Response to Comments

Draft Revisions to Sabey Data Center Air Quality Permit 16AQ-E011

*Summary of a public comment period and responses to comments on
revisions to an existing air permit*

Proposed permit:	Revisions to the Sabey Data Center Air Quality Permit 11AQ-E424 Quincy, Grant County, WA
Comment period:	December 10, 2015 – January 10, 2016
Date final permit issued:	Approval Order 16AQ-E011 issued on April 20, 2106

Figure 19. Cold-start emissions for CO and NO_x as a function of time

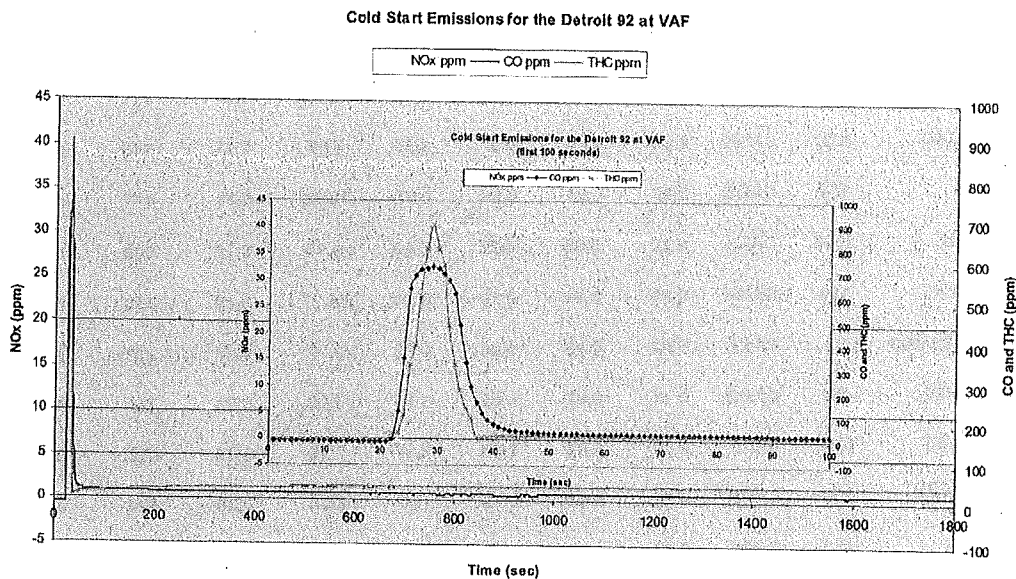
Appendix E limits the application of the "cold start" factor to the first 15 minutes of engine operation. Because the information⁴ from which Sabey derives its "cold start" factor is based on emissions that take place in the first 30 seconds of the engine startup, the mass of the emissions should be added to each engine run and recorded as part of

The California Energy Commission chart (Figure 19 in their report) shows the cold start spike in emissions lasts for only about 20 seconds, but Sabey averaged that spike over a 15-minute period, then used the 15-minute cold start factor to calculate the 1-hour, 24-hour, and annual-average emissions by assuming a reasonably high number of cold starts. For the first 15 minute cold start period, the calculated “15-minute cold spike factors” are 1.26 for PM and VOC, and 1.56 for CO. The choice of the 15-minute average cold start period does not affect the calculated results for the calculated 1-hour, 24-hour, and annual-average emissions. The same 1-hour, 24-hour and annual-average emission rates would result if you assumed cold-start periods of different durations.
